RE: PROJECT #P12479 STORMSTATION 2 FIXED EMERGENCY GENERATOR

In summary, the DDA requests that the location of the proposed Stormstation 2 Fixed Emergency Generator be moved to the location shown in the attached site plan (Exhibit 1), closest to the southern edge of the SE 1st Avenue cul de sac. With this relocation, the DDA confirms our intent to pay for the additional design and construction costs that are determined to be reasonable and necessary. Further, the DDA requests that the City and its generator contractor continue to work in good faith with the DDA and the Huizenga Park contractor to complete these two projects in a manner and schedule that expedites completion and minimizes impacts to each party and project.

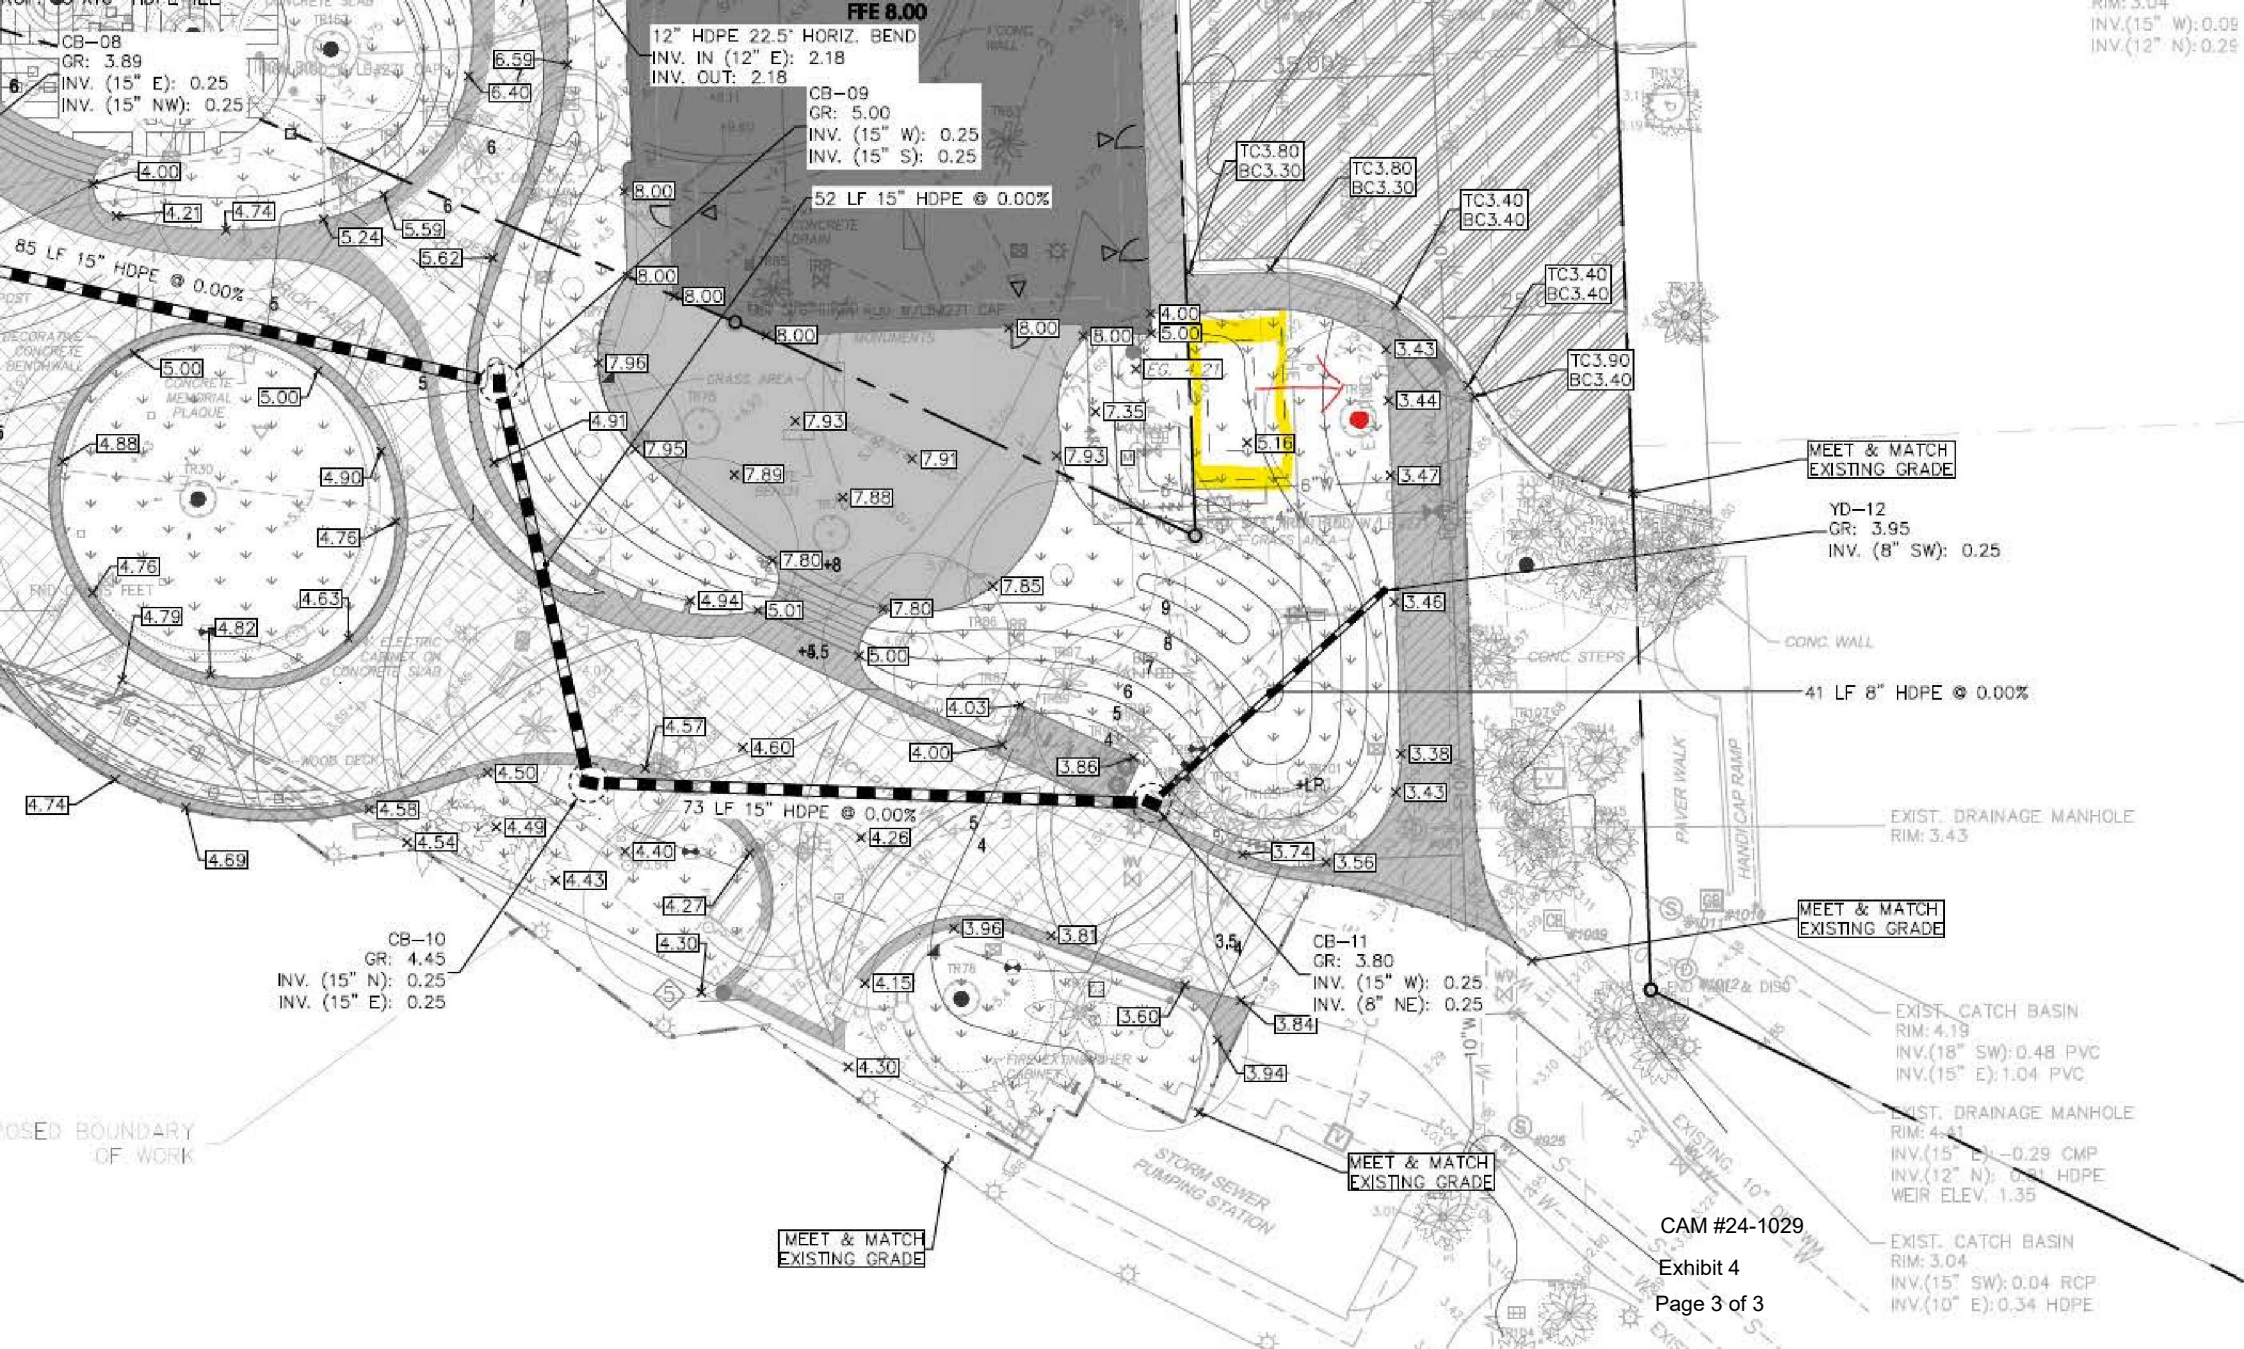
It is the desire of the DDA that the generator be sited in an area that has the least negative visual and physical impact to the proposed Huizenga Park plan, including the location of the approved outdoor dining terrace along the Riverwalk. Exhibit 2 is a plan excerpt that further illustrates the proposed design of Huizenga Park with the revised site elevations and shows how the generator could be shifted further east if an existing tree were to be removed.

During a site meeting on November 4, 2024, it was agreed upon by Public Works staff and DDA staff that the City will coordinate with the generator contractor after contract award to determine the scope of work for a likely change order and the additional costs to move the generator from the designed location to the DDA-preferred location. We look forward to meeting with Public Works staff, the selected generator contractor and the City's engineering design consultant as soon as possible to advance these next steps.
